SERVICE BULLETIN - SB031

I.C.P. Srl

SERVICE BULLETIN 31 - Extruded of Main Spar-Rev00

Figure 1: Left front strut attachment to the spar

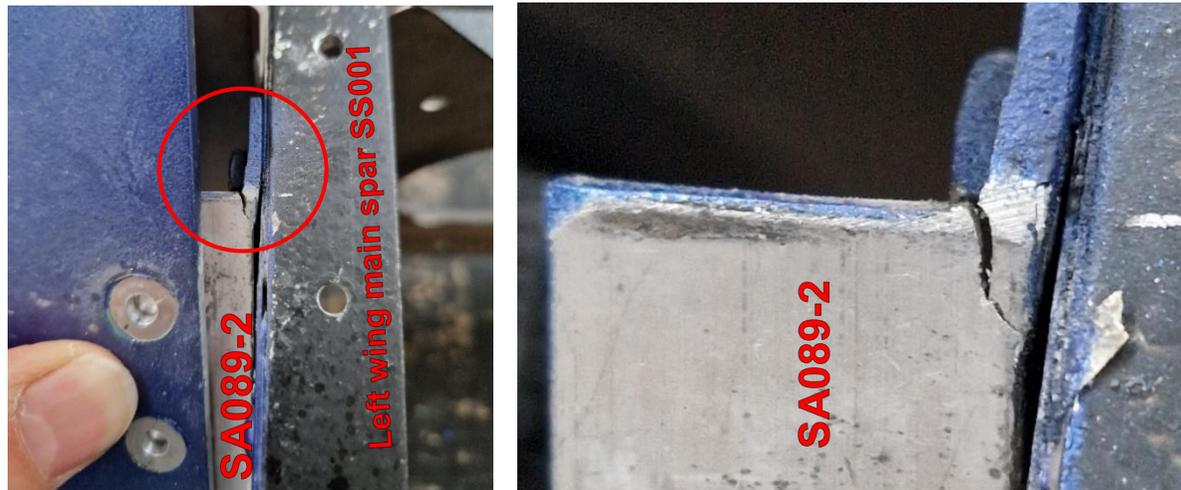
Replacement of the extruded bars of the main wing spar attachments: SA089-2 and SA090-2. See *Figure 1* and *Figure 2*.

On the *Savannah VG* aircraft, it has been discovered a crack on the subject parts, during a reparation of the wing.

Figure 3: Right Wing, partial opening of the upper skin, to access the area of intervention

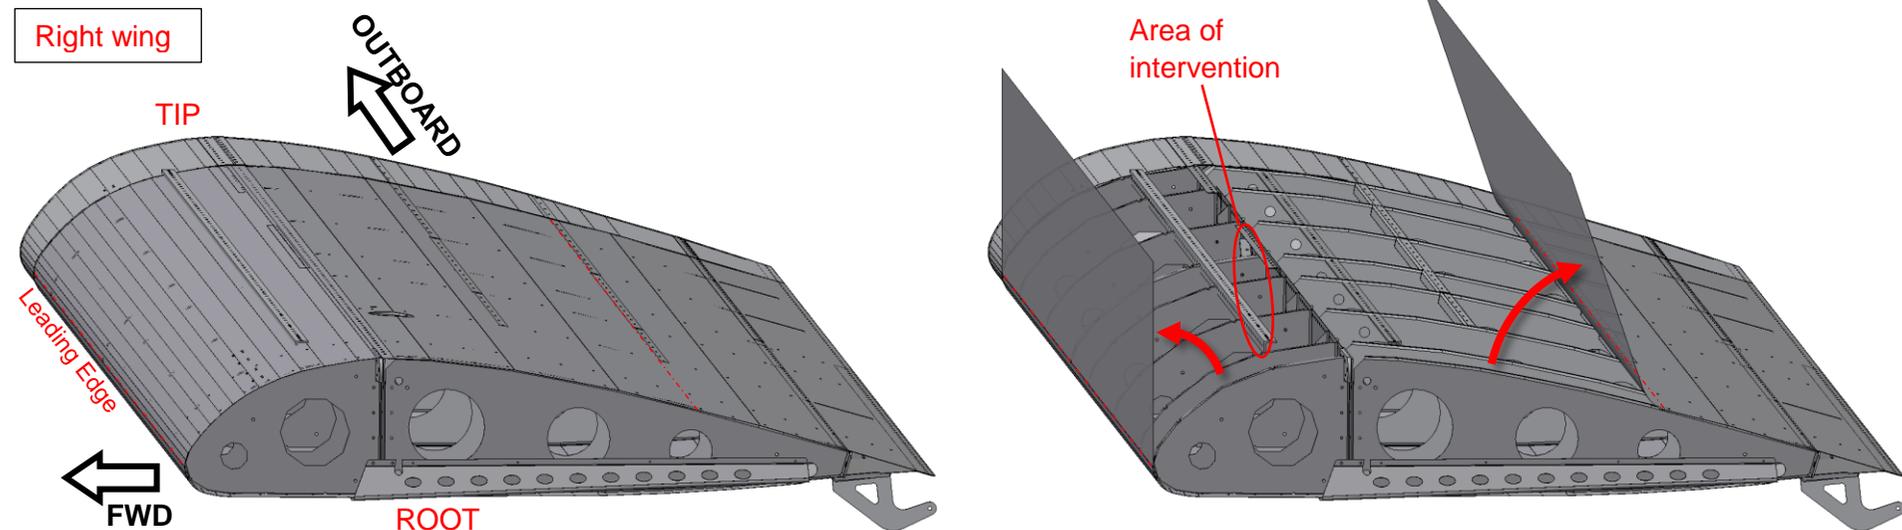
First, unrivet the L.E. skin: drill the pop rivets $\text{Ø}3.2$ [mm] and $\text{Ø}4$ [mm] with relative drill bits, then pull the skin up like shown in *Figure 3* (shown the right wing, do symmetrically on the left wing).

Then, unrivet the top skin: like before, drill the pop rivets and separate the skin from the spars, the ribs and the stringers below (if present) up to the last stringer before the rear spar (shown in *Figure 3*).

ATTENTION: Be very careful not to buckle the upper skin, while lifting it up.

Figure 4: Right Wing, area of intervention from the front

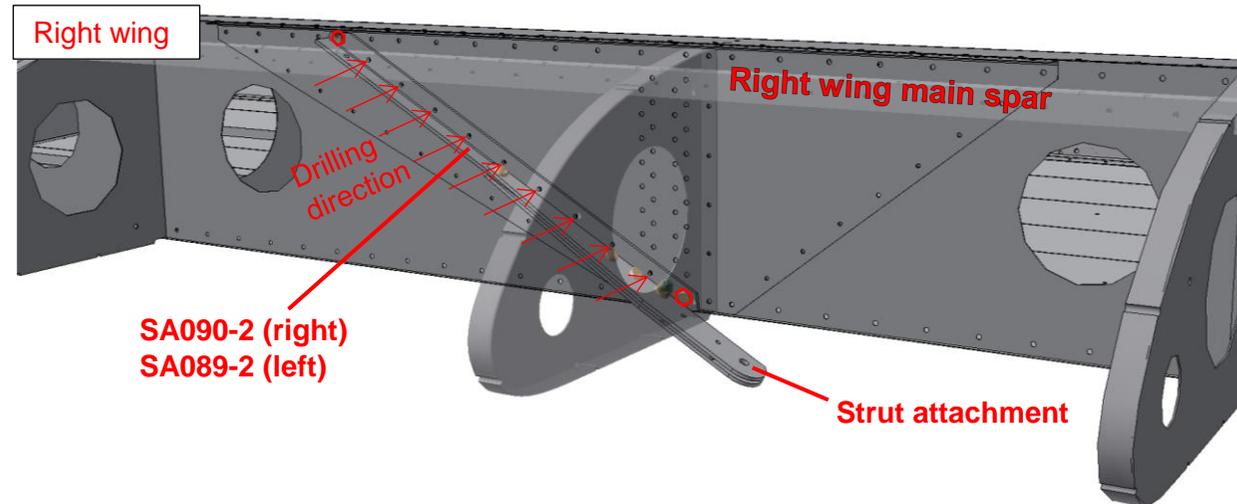
Before unmounting the extruded part, remove the front strut attachment plates (same on both the left and the right wing). Those are bolted with AN3 to SA089-2 (left) and SA090-2 (right).

To remove the part SA090-2 from the right wing (SA089-2 on the left wing), drill $\text{Ø}6$ [mm] just the tail of the solid rivets (from the front of the wing, like the view of *Figure 4*), in order to remove only the bulbous ends of the rivets.

Then, drill $\text{Ø}4$ [mm] centered to the axis of the rivets, up to completely remove them. Pay attention to not excessively press the rivets when drilling, to not bend the main spar web.

Figure 5: Right Wing, area of intervention from behind

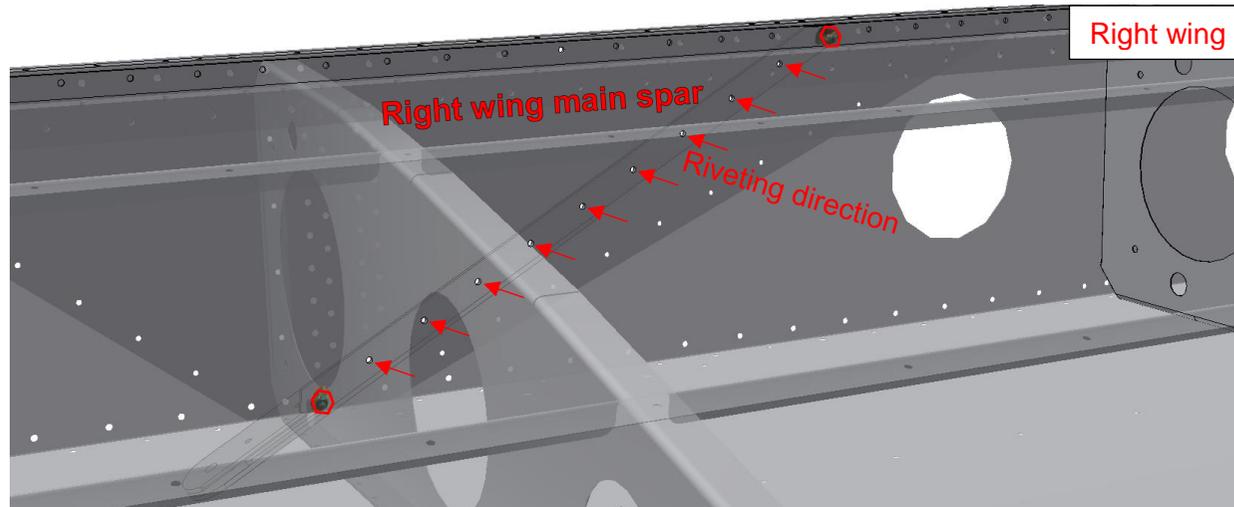
Now, install the new SA090-2 on the right (SA090-2 on the left) applying the following sequence of operations:

- Install the new set of AN3 bolts with self-locking nuts and washers, like shown in *Figure 5* and;
- Rivet the extruded part with Ø4 [mm] steel pop rivets to the main spar web.
ATTENTION: the head of the rivets must be oriented behind the spar, therefore the tail of rivets must be pressing on the extruded part, like shown in *Figure 5*;
- Reinstall the front strut attachment plates with the proper sequence of bolts, washers and self-locking nuts;
- Close all the AN3 bolts/nuts at 6 [Nm] with a torque wrench.

Figure 6: Right Wing, sequence of riveting top skins

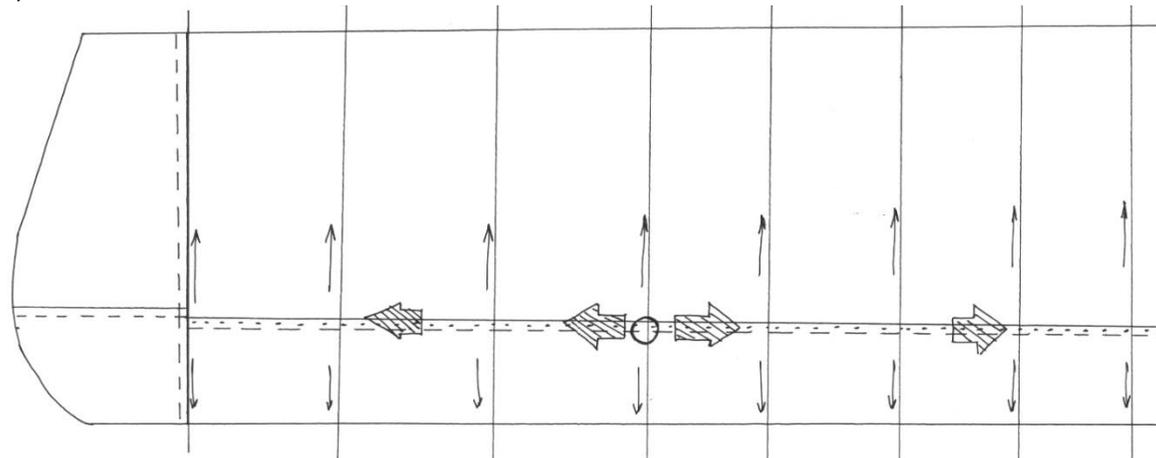
- Rivet entirely the top rear skin of the wing;
- Rivet entirely the top nose skin of the wing.

ATTENTION: The riveting sequence must follow a certain order, as explained in *Figure 6*, also according to the *Construction Manual* of the airplane (Wing Chapters);
